STATE OF MINNESOTA
BEFORE THE PUBLIC UTILITIES COMMISSION

*In the Matter of Xcel Energy's
2020-2034 Upper Midwest
Integrated Resource Plan*

PUC Docket No. E002/RP-19-368

CLEAN ENERGY ORGANIZATIONS' SUPPLEMENTAL COMMENTS

Figure 1. CEO Alternate Plan Capacity Expansion Plan (2020 – 2034)⁵³

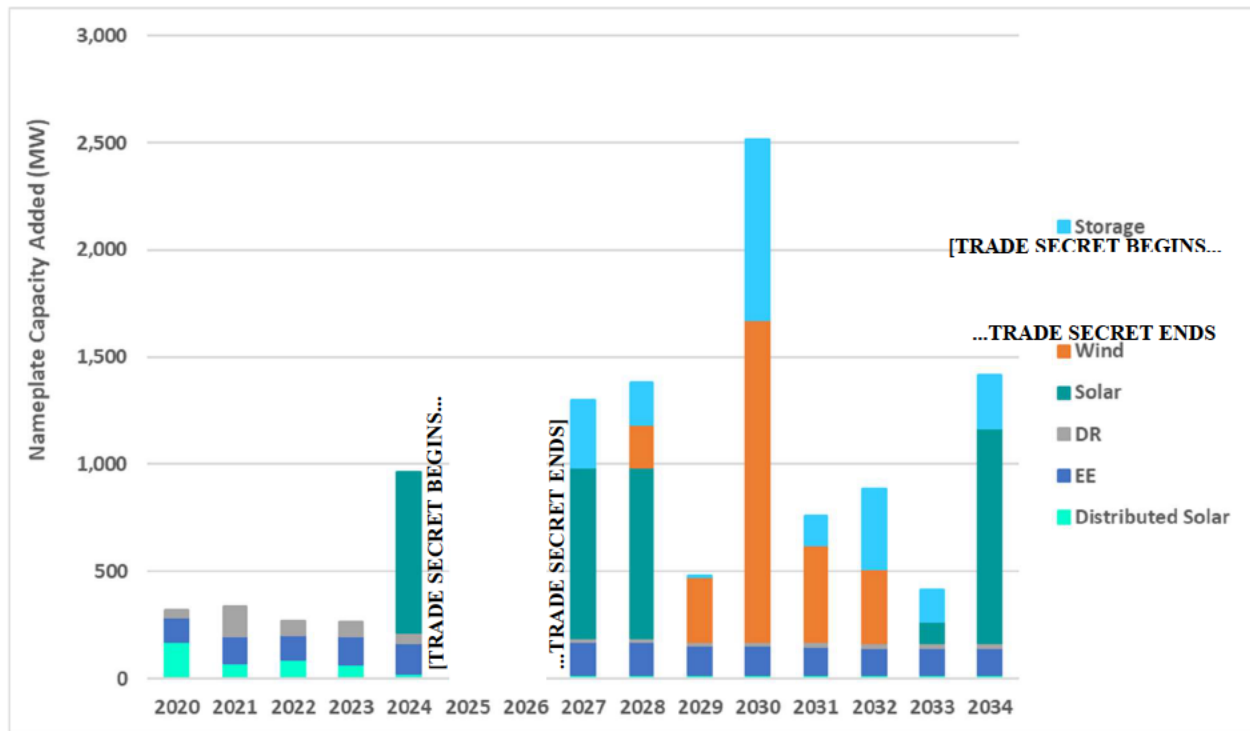
Re-running Xcel’s Alternate Plan model with the above two basic changes resulted in a plan without the two new proposed CTs and, similar to CEOs’ Preferred Plan filed in our initial comments, no new fossil resources added throughout the planning period. In addition, this new plan, which we refer to as the “CEO Alternate Plan,” adds a significant amount of solar-battery hybrids, among wind, solar, and standalone battery storage additions. Between 2027 and 2029, the CEO Alternate Plan adds 450 MW of solar hybrid, 400 MW of battery storage hybrid, 116 MW of standalone battery storage, and 100 MW of wind in place of the proposed new CTs.⁵² The CEO

Alternate Plan Capacity Expansion Plan through 2034 is shown here in Figure 2 from the EFG Report.

Figure 2. Weighted Average Capacity Factor (%) of Xcel's CTs During Arctic Event⁵⁹

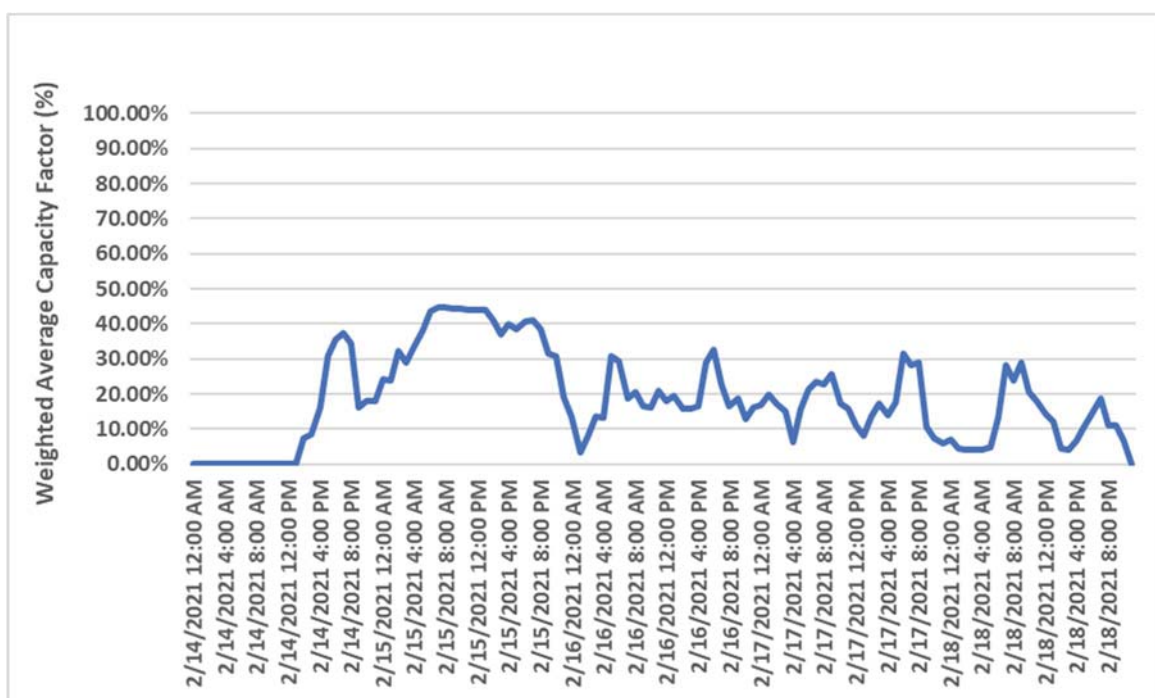
EFG's report reviewed the operational data for Xcel's existing CTs during the 2021 Winter Storm Uri between February 14th and 18th, 2021.⁵⁷ EFG's review found that six of Xcel's CTs did not operate during any hour of Winter Storm Uri.⁵⁸ The CTs that did operate during the event did so at well below their full capacity, as seen in the EFG Report's Figure 3, below.
